Teven Quarry Blast Management Plan

Holcim Australia
April 2021 Update

**Teven Quarry (SSD-6422)
Request for Additional Information**

Attachment A
Teven Quarry
Blast Management Plan Reviews – Oct 2020

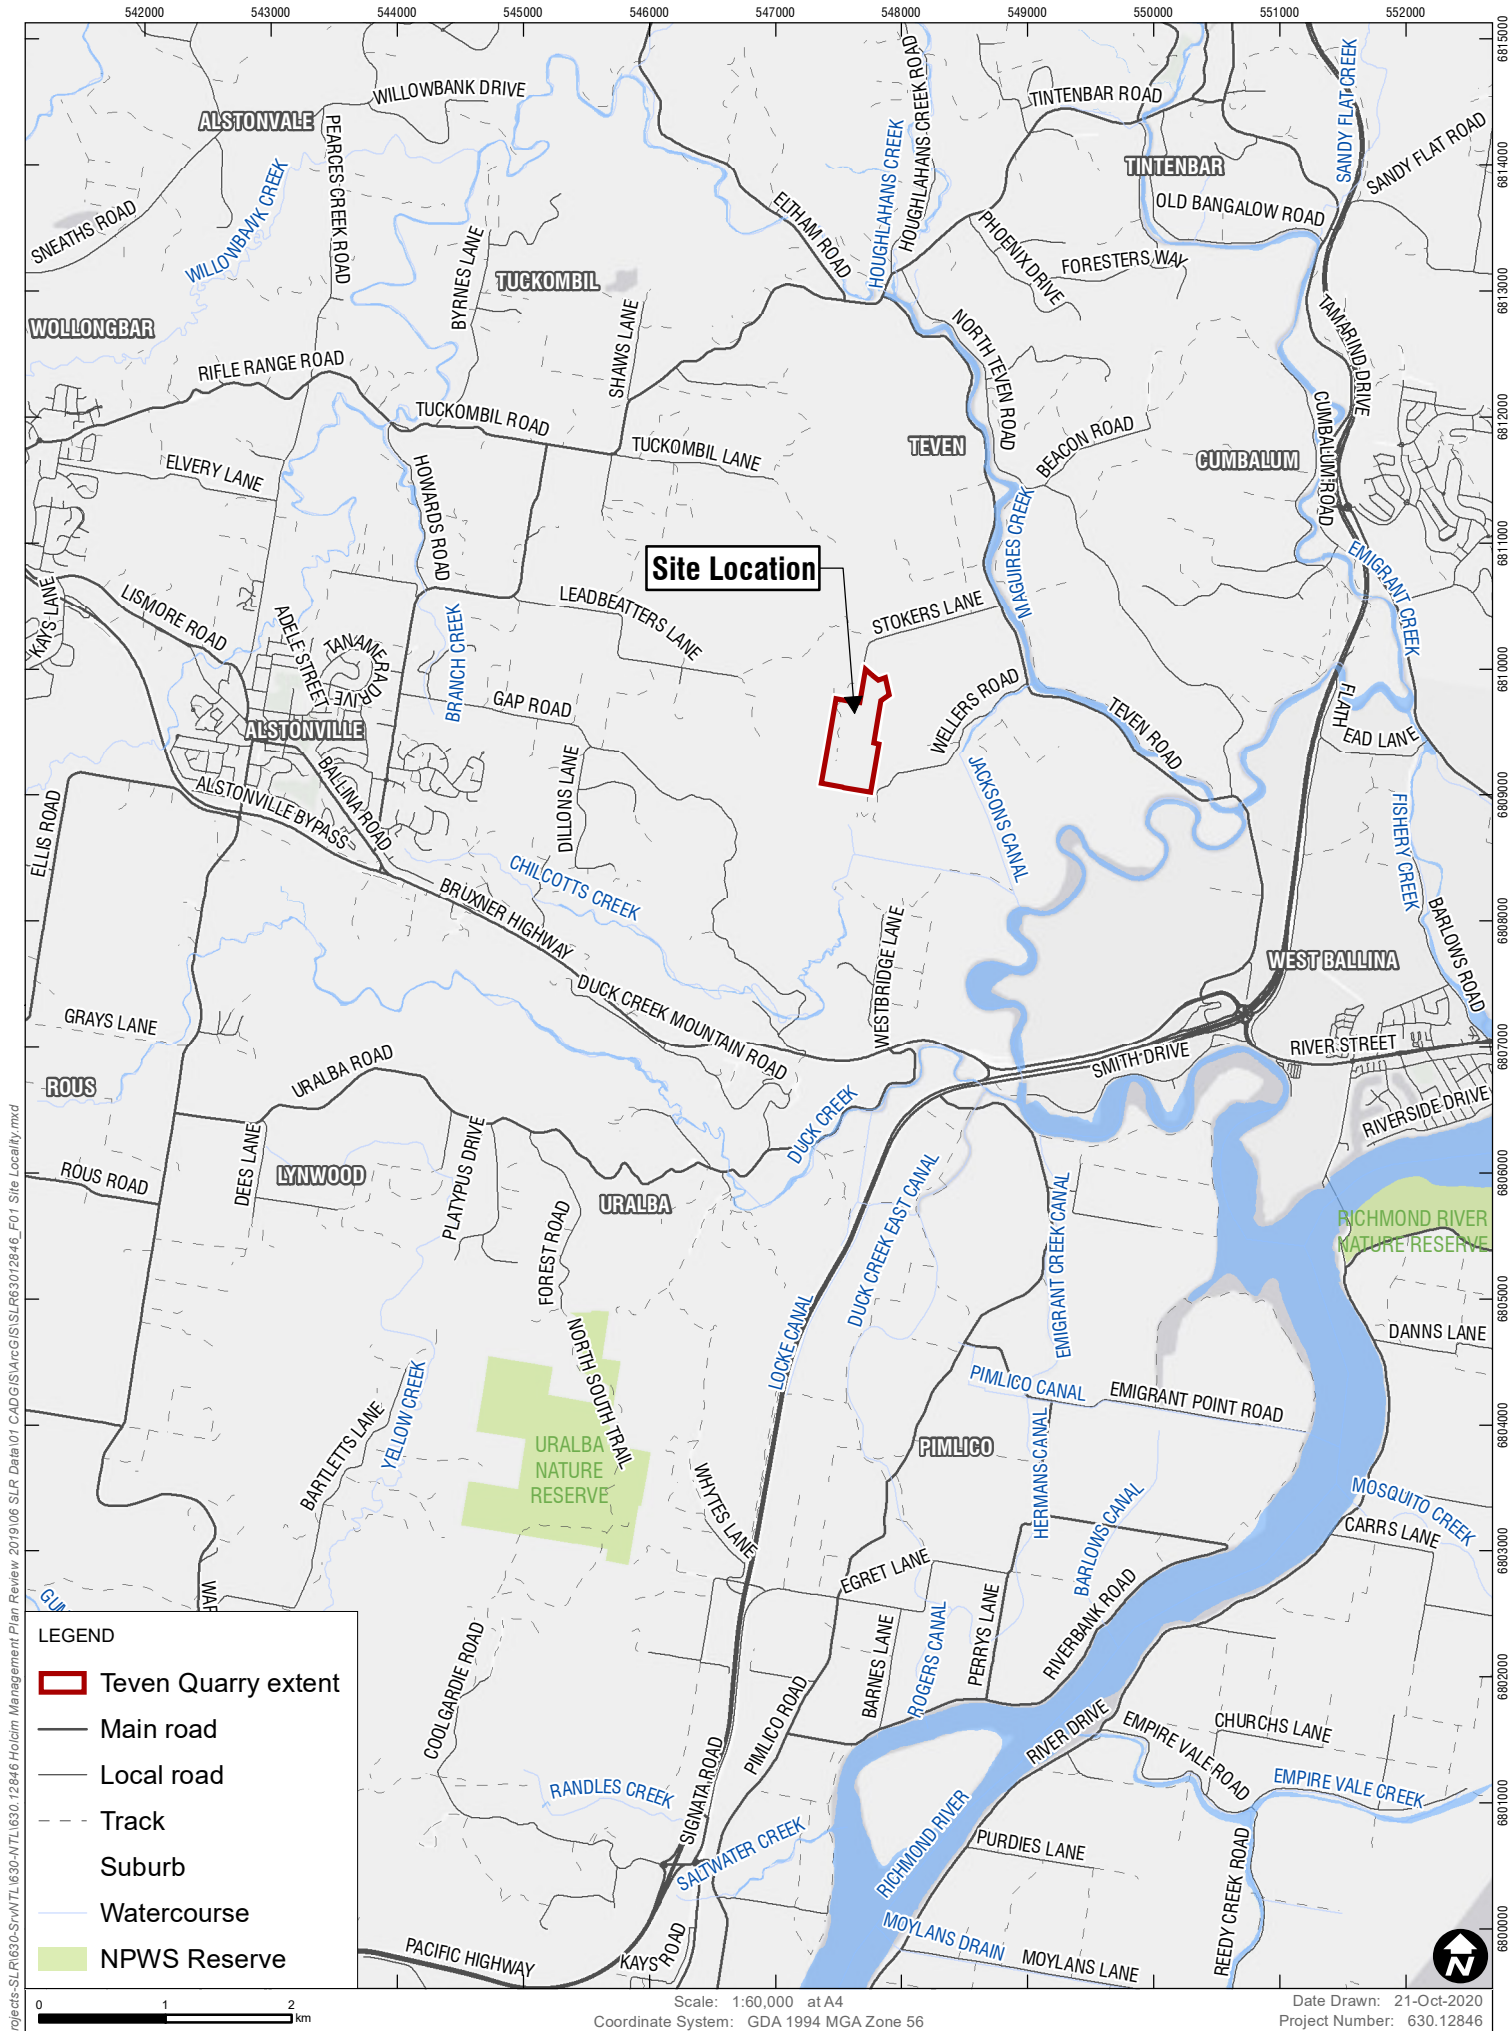
Other Comments on Blast Management Plan	Holcim Response
- The BMP is not to an acceptable standard. - Figure 1 location does not show the current location of the Pacific Highway. - S.9.3 What is INX?	- The previous BMP (EMM, 2016) as a reference document in Table 7. - Figure 1 has been updated. - INX has been expanded.

Figure: Example of modelling undertaken by blasting contractor to determine exclusion zone.

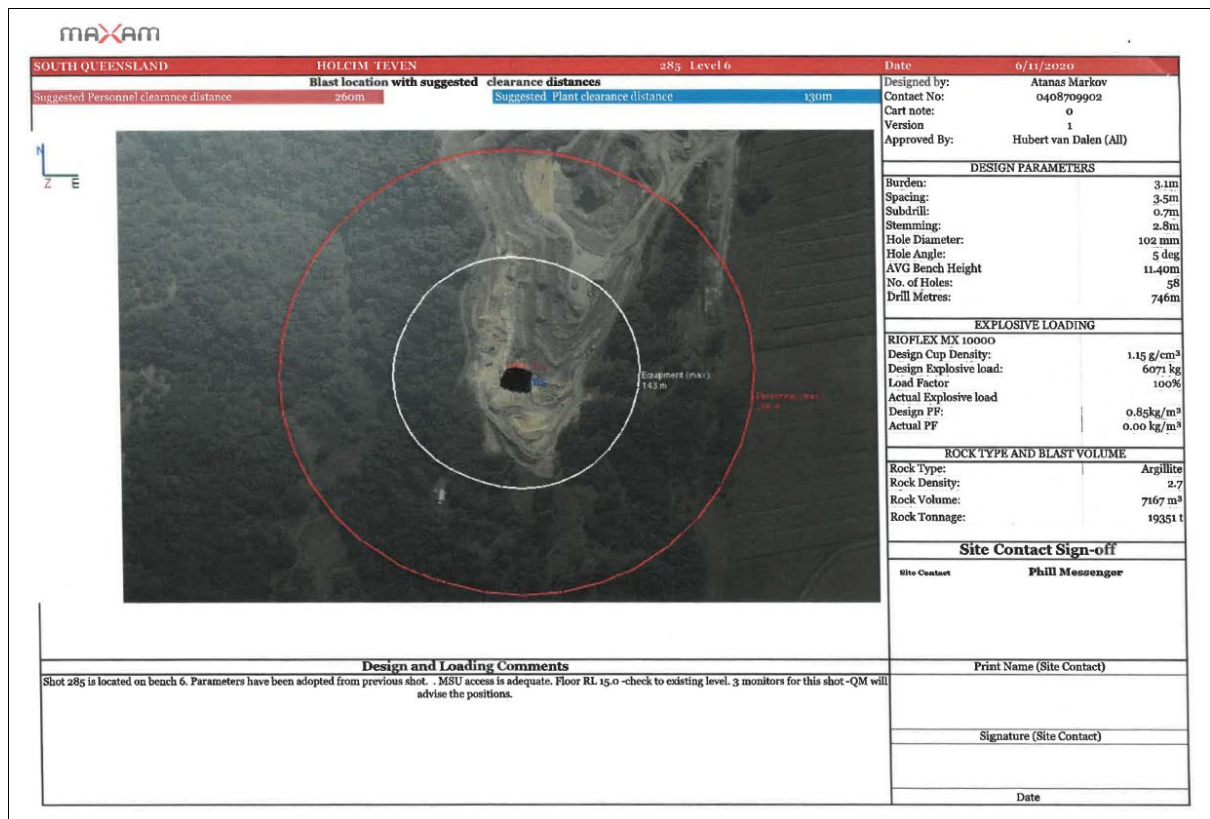
Blast Management Plan, Schedule 3, Condition 10	Satisfactory (Yes/No)	Comment	Action Required	Holcim Responses
		- T.7 BL5: Provide a description or a map if appropriate of how the exclusion zone is determined? - T.7 BL7: change “nearest” to “any sensitive receiver”.
